BAR 03-08-02
400 E. Water Street
Tax Map 28 Parcel 60.2
Install new window and replace trees
Tim Michel, Applicant/ Outlaw Design, Architects

**CITY OF CHARLOTTESVILLE
BOARD OF ARCHITECTURAL REVIEW
STAFF REPORT
August 19, 2003**

BAR 03-08-02
400 E. Water Street
Tax Map 28 Parcel 60.2
Install New Window and Replace Trees
Tim Michel, Applicant/ Outlaw Design, Architects

King Building on Water Street

fig. 5

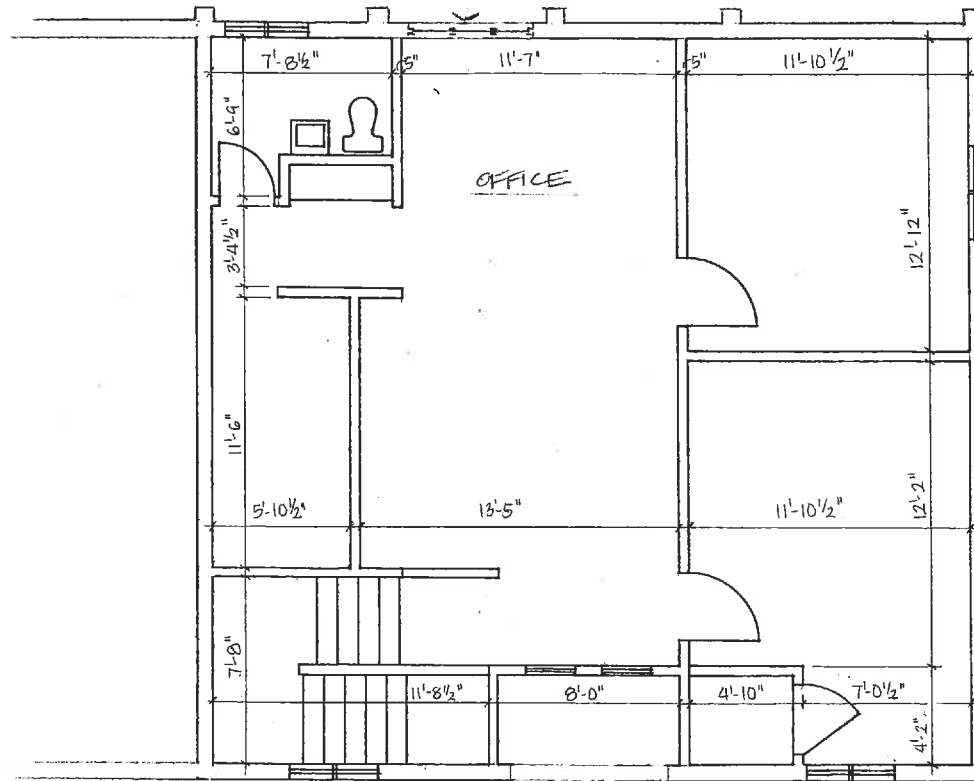
The issue regarding the new window is whether a new opening should be cut into the brick building where there has not been an opening. There have been new openings placed in this building during previous remodelings. The window is larger than the other punched openings but is placed between pilasters on the rear elevation so that it will not have an adverse effect on the building or district.

Staff recommends approval of the new window as submitted.

The BAR unanimously approved (7-0) your application to add a window in the rear, as submitted. They also allowed staff approval of a smaller window opening subject to staff consultation with the BAR.
